**Document No.:** RN-210115-01  
**Date:** January 11, 2021  
**Classification:** External  
**Attn:** All customers  
**Related Products:** C700  
**Subject:** C700 Software Release Note (ver. 1.1.4)

Intellian is pleased to release updated software for the Intellian Iridium Certus terminal, C700. Please apply the firmware update to the models in Table 1.

Figure 1 Data Limits & Data Usage monitoring

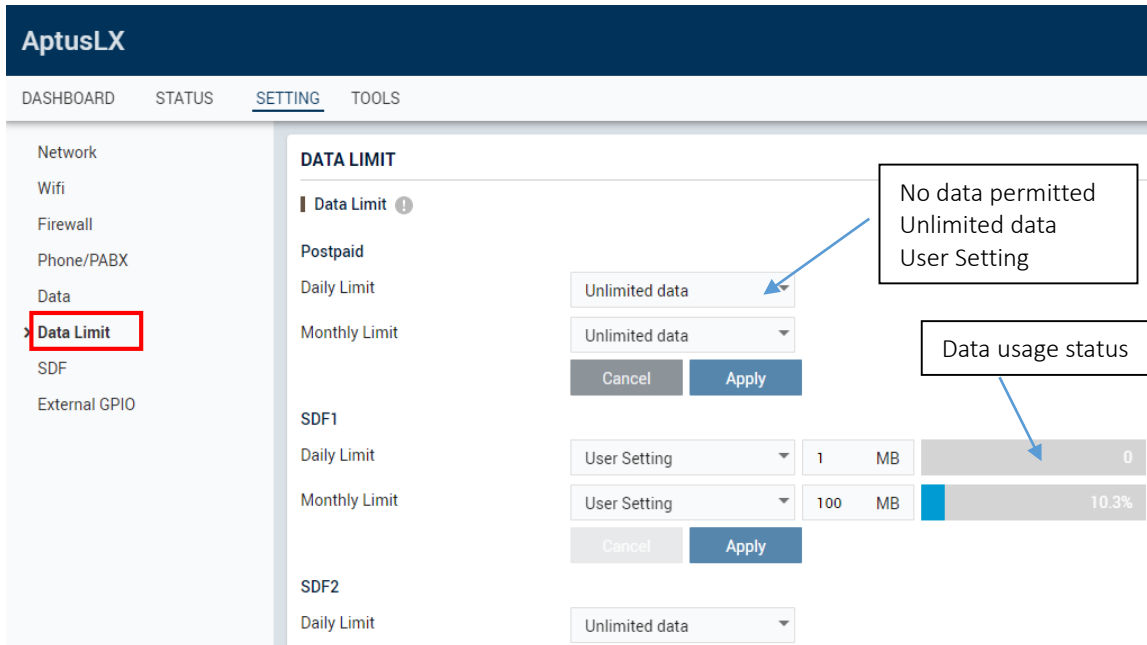
1.1 The function which restrict the data usage and alert the excess of data limit has been added.

- Daily data limits, Monthly data limits for postpaid and SDF 1~SDF 4
- Display satellite data usage in Dashboard
- Alert message when the data usage exceeds the data limits

Figure 2 Tooltips in the menu

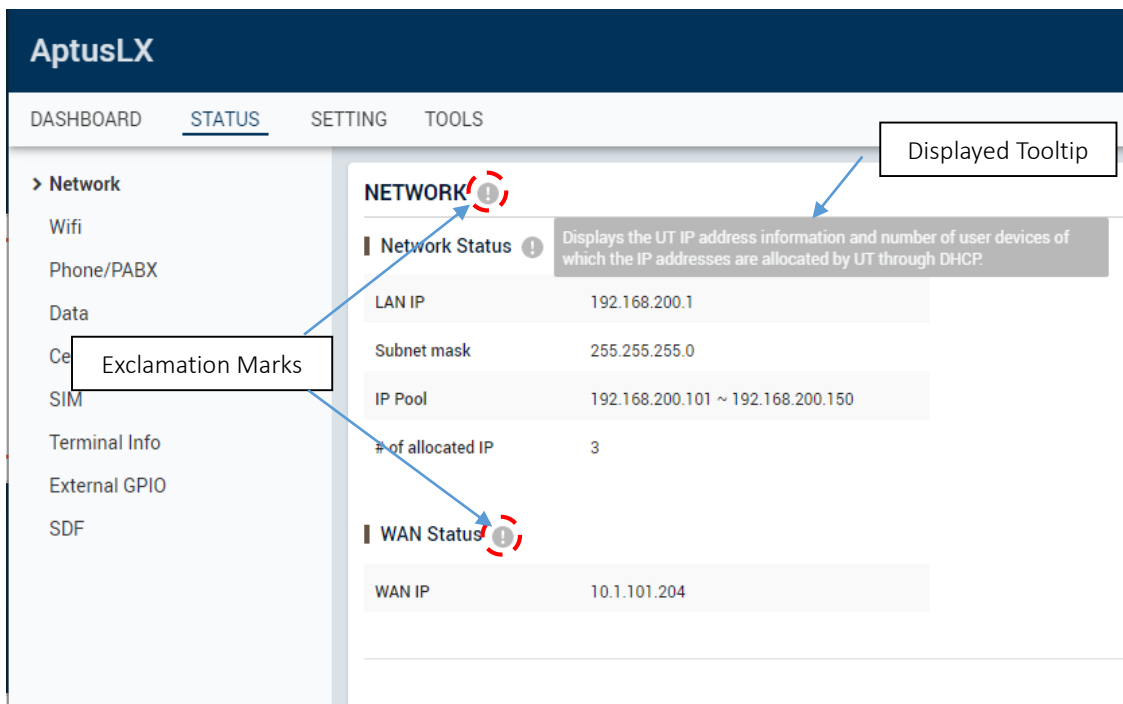
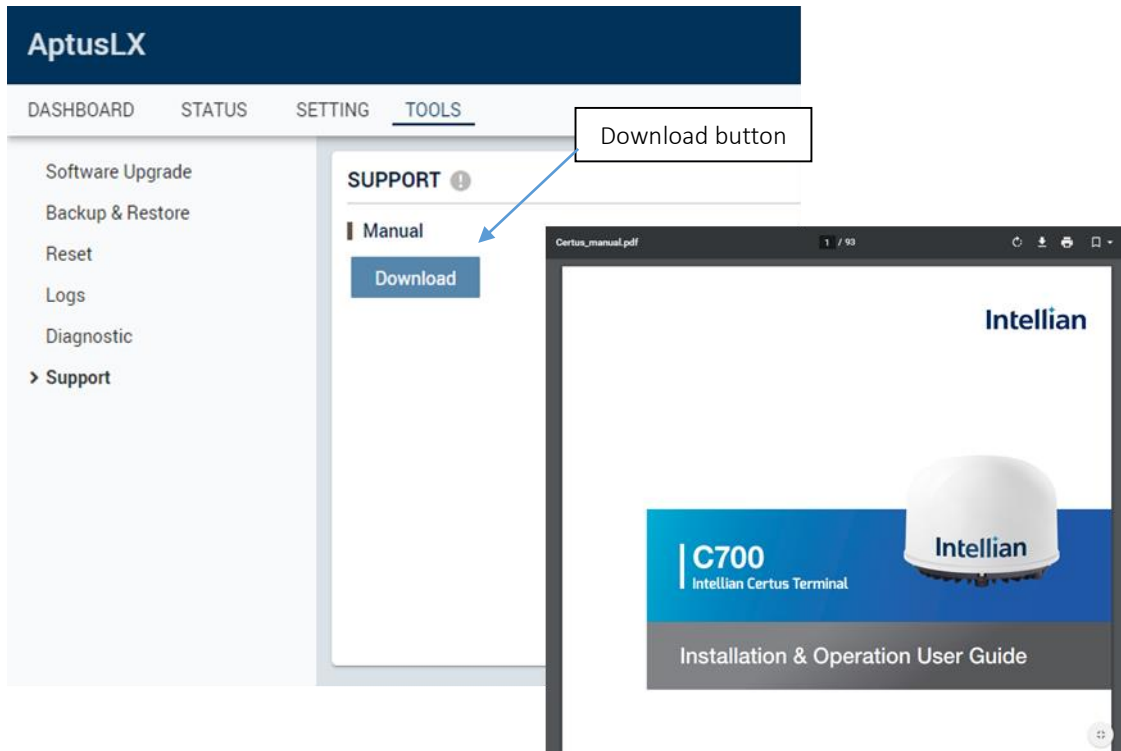
2.1 Tooltips has been displayed to understand items well if moving the mouse over a “exclamation mark” of each item
